Planning and Zoning Board Agenda December 10, 2019

SUBJECT: Site Plan - Golf Plaza: A request by Daniel Young, P.E. of CHW, inc., applicant and agent for Nature Valley Harvest, Ltd, property owner, for consideration of a Site Plan to construct three commercial buildings totaling $\pm 25,028$ square feet, with associated paving, grading, drainage, landscaping and infrastructure improvements, on a ± 8.25 acre subject property, located southeast of the Intersection of US HWY 441 and Turkey Creek Boulevard, north of the Turkey Creek Subdivision; Tax Parcel Numbers 05900-004-001 through 05900-004-010 (Quasi-Judicial Hearing).

Planning & Community Development Department Staff Report

SUBJECT: A request for a Site Plan for the construction of three buildings totaling $\pm 25,028$ square feet with employee and customer parking, storm water management facility improvements, paving, grading, landscaping and associated utility infrastructure

1
2
3
4
A
B
C
D
Title: bryang Plot Date: Nov 21, 2019 11:03am Filename: \\A\2018\18-0431\Engineering\DWG\Production Files\3.10 Detailed Utility Plan.dwg

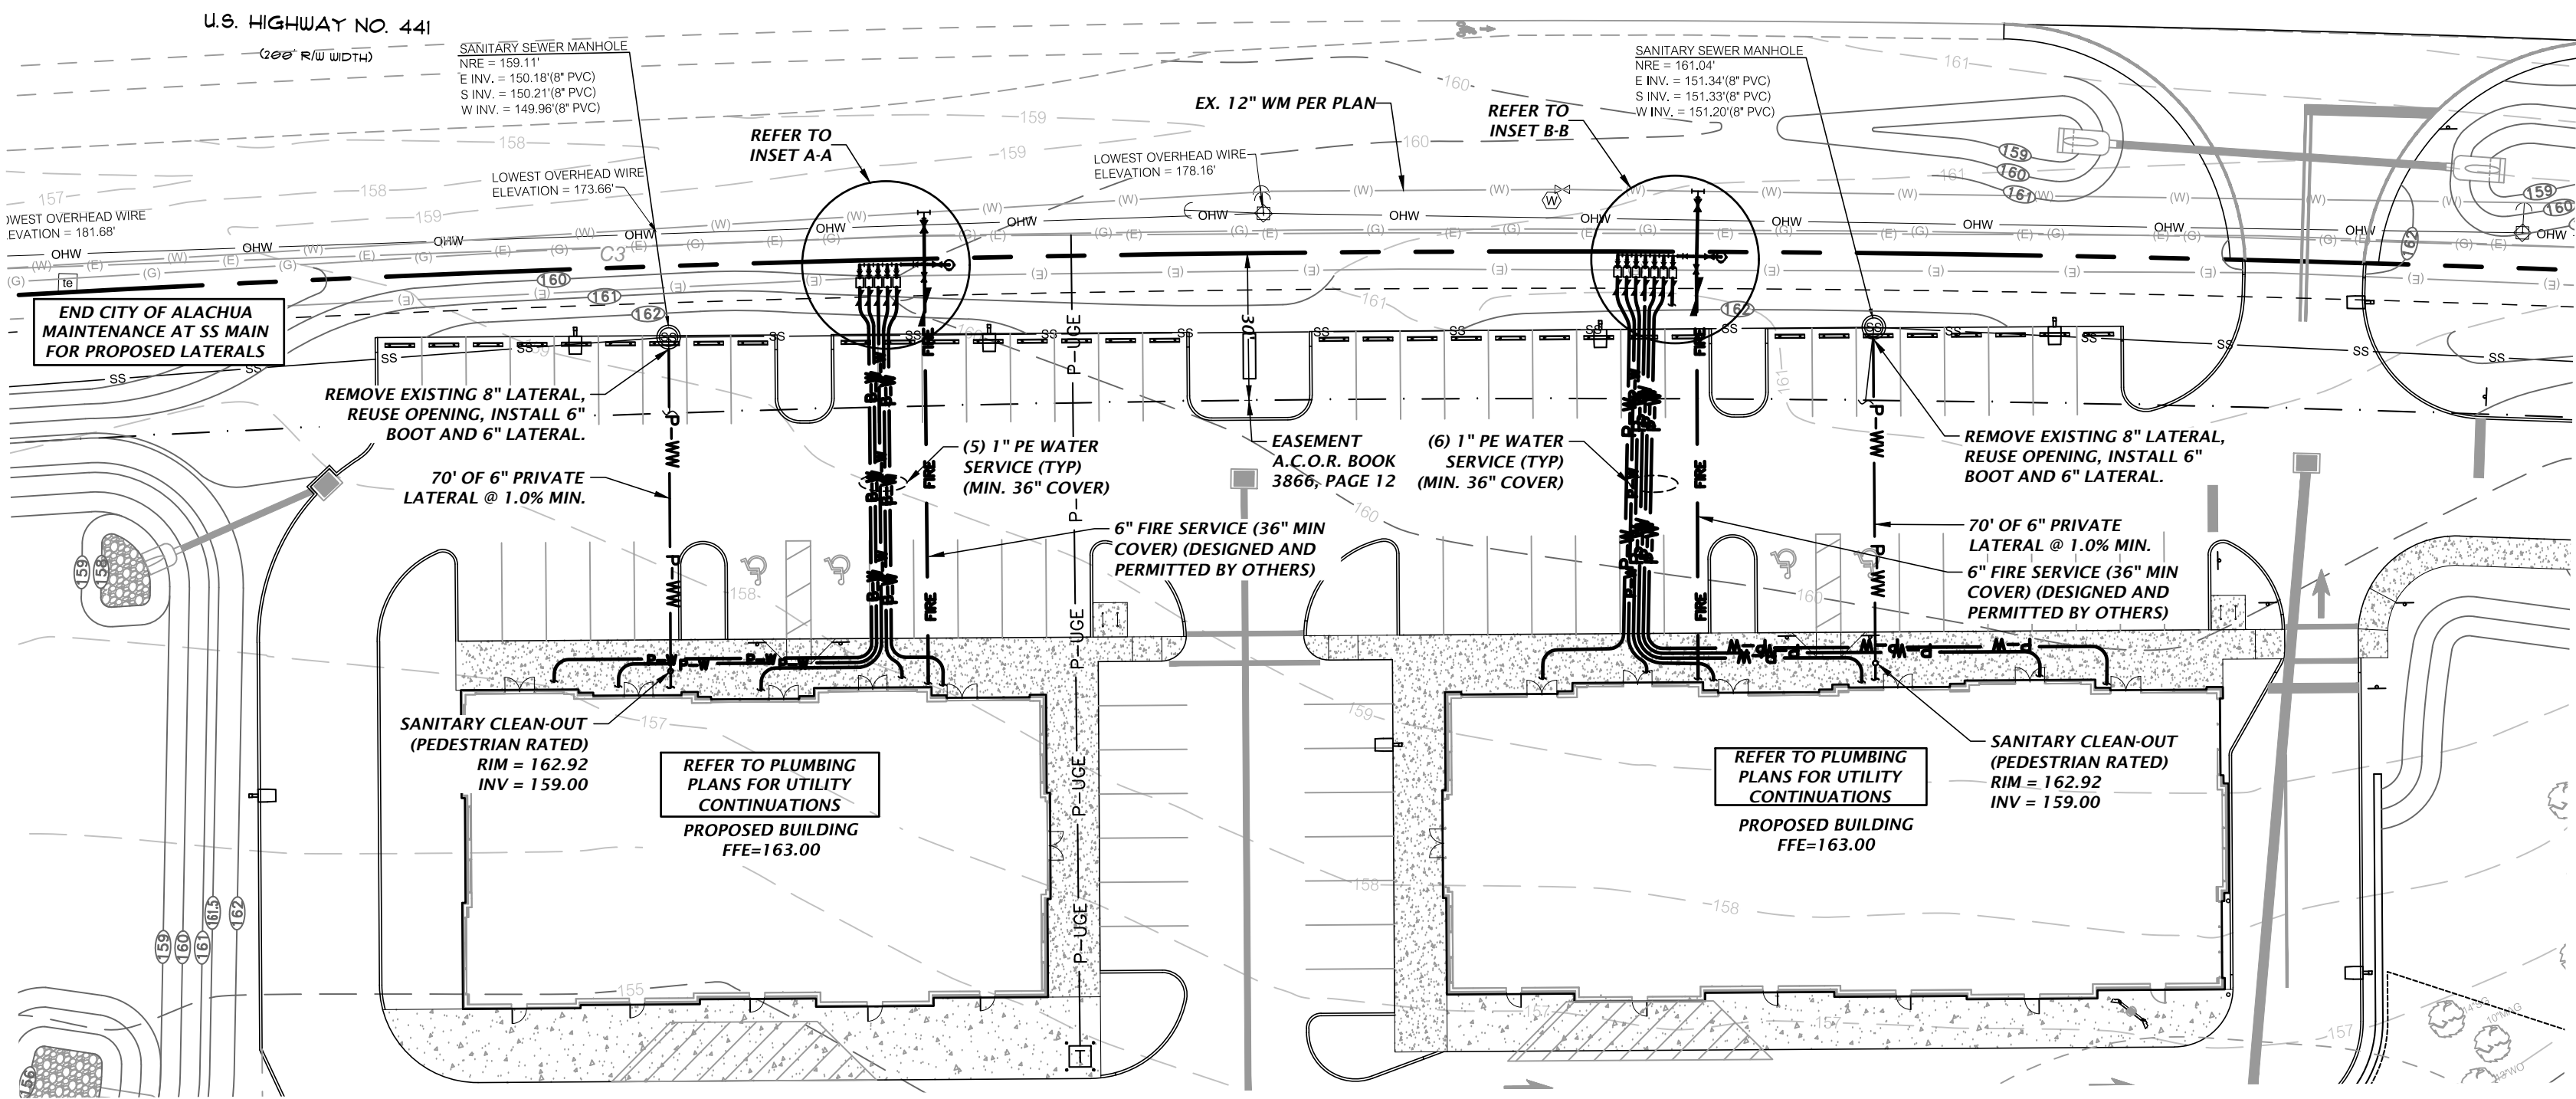
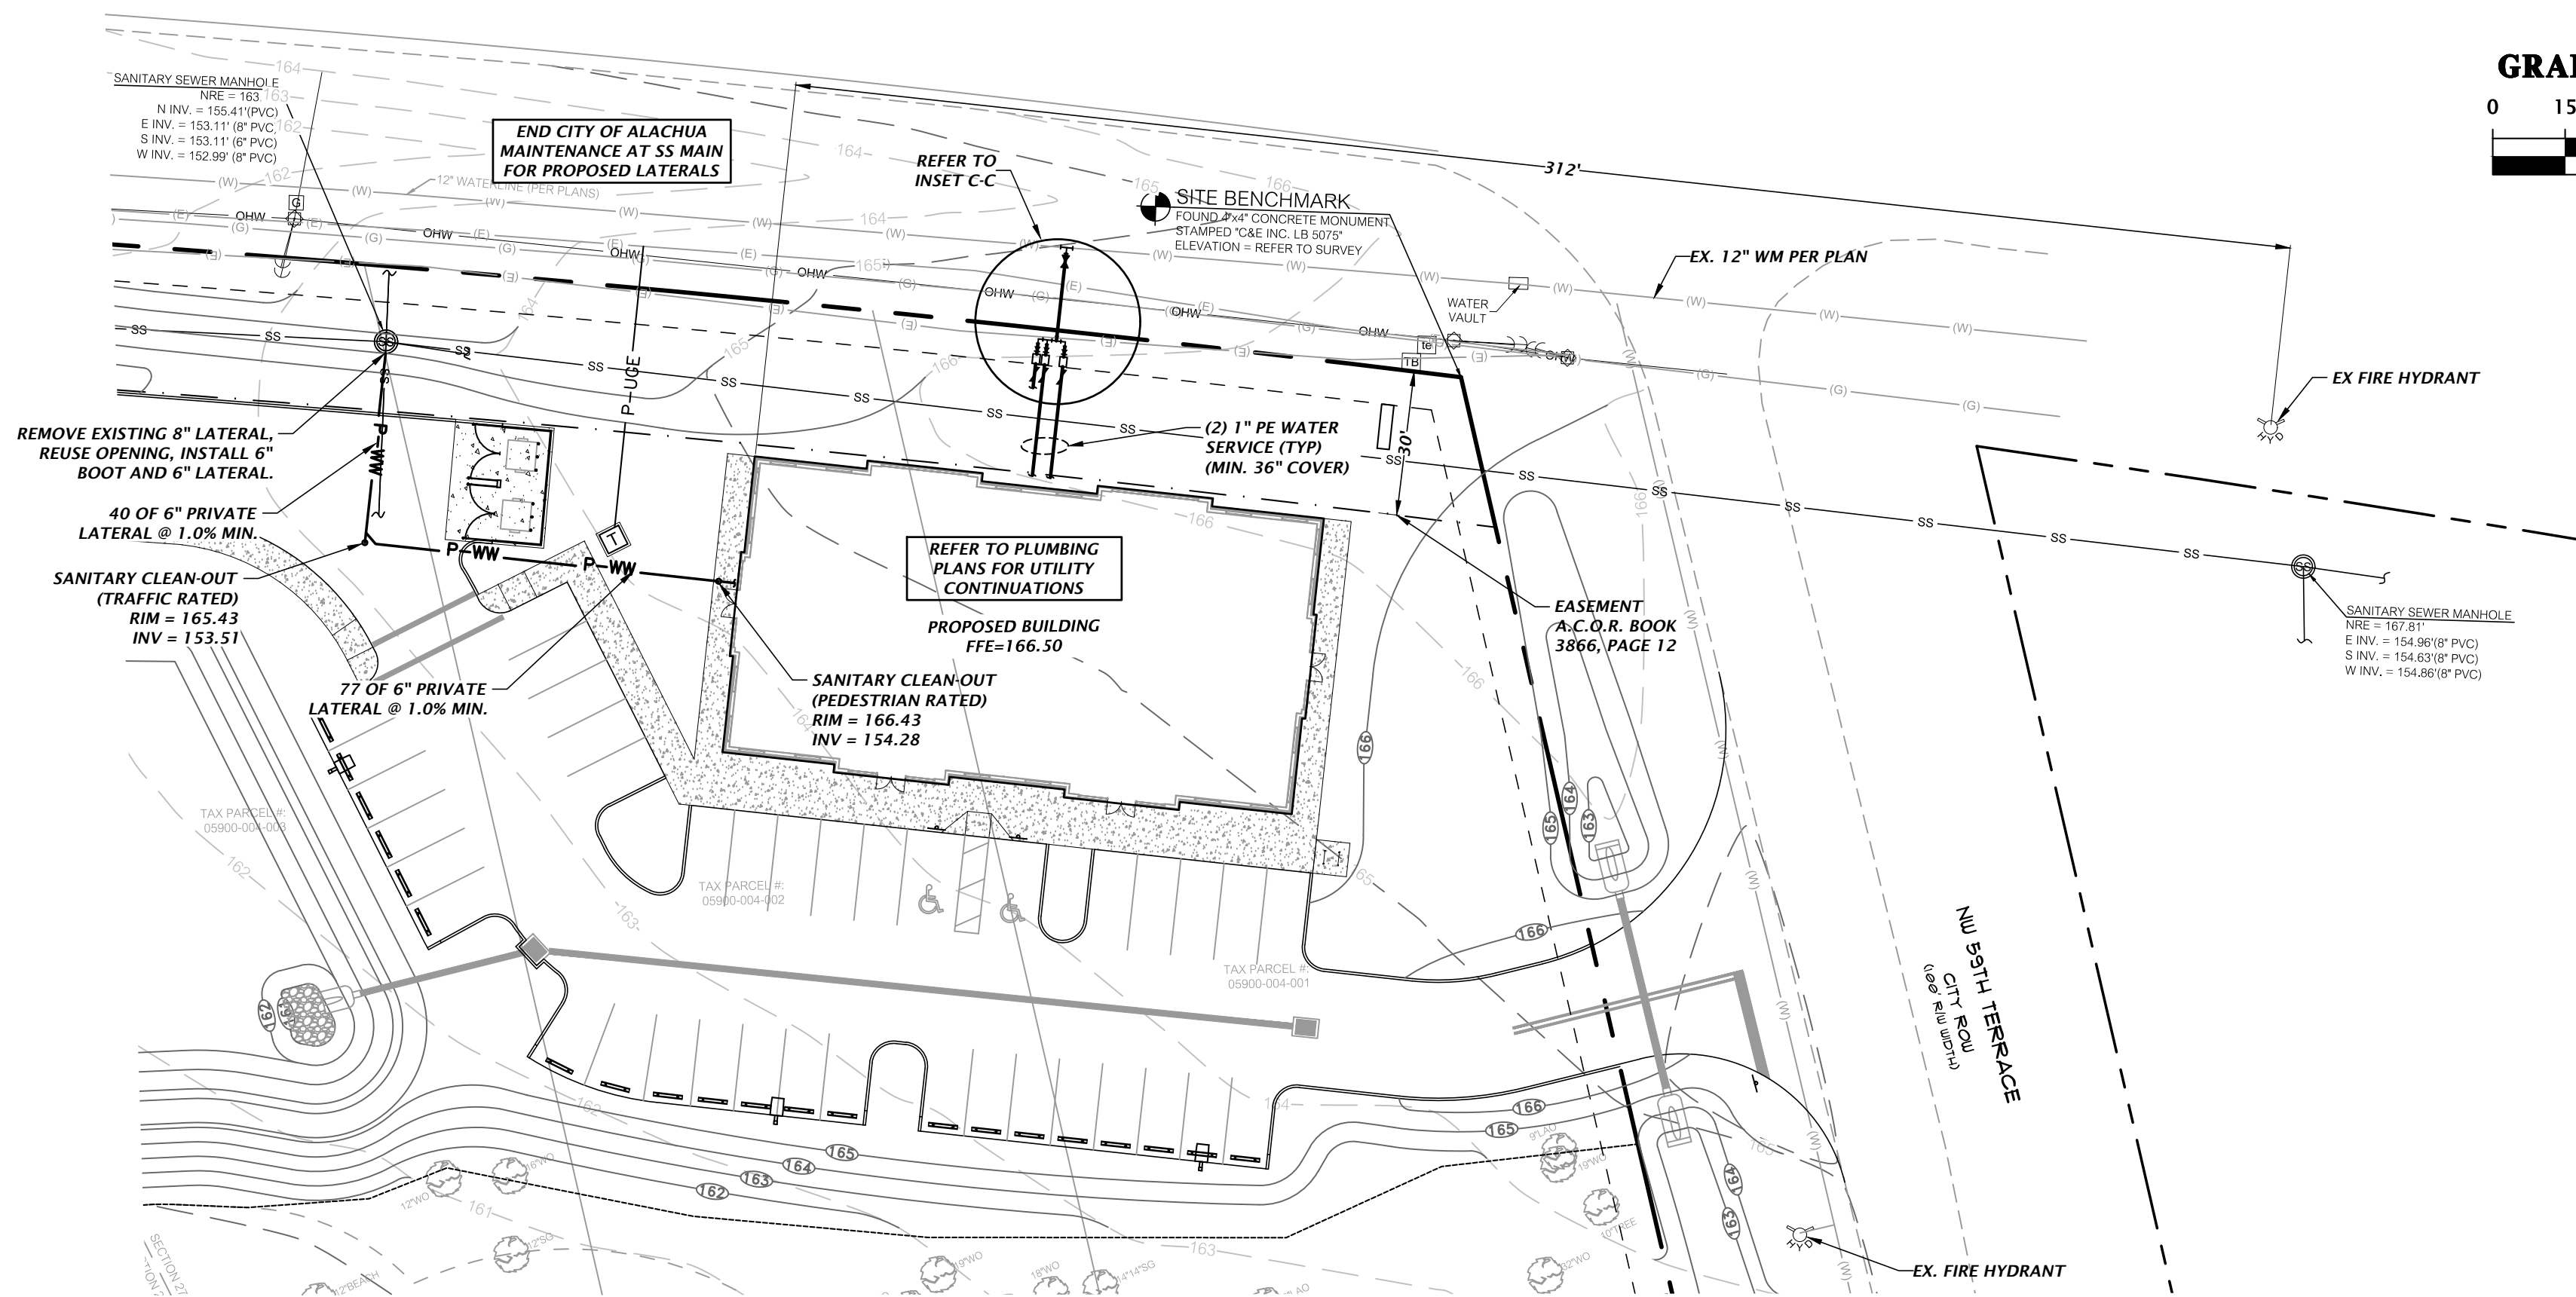
6.	Previous Submittal Comment Sheet C3.10 • Inset CC: Item 7 is a 12- x 3-inch tap and wet valve. Inasmuch as 3-inch piping and fittings are not a CoA standard, please replace with a 12- x 4-inch tap and wet valve. Please select downstream piping such that 3-inch piping is not installed. Please change fitting schedule. Current Submittal Comment Approved

Harry Dillard – Lead Engineering Technician

4. Cleanout: DWG C3.10 says that City of Alachua (CoA) maintenance ends at the existing SS lines, meaning CoA is not responsible for maintaining the laterals. Please confirm. If CoA is responsible for maintaining the laterals, the CoA would prefer that tracer wires be added to the laterals.
 - **CoA is not responsible for maintaining the laterals.**
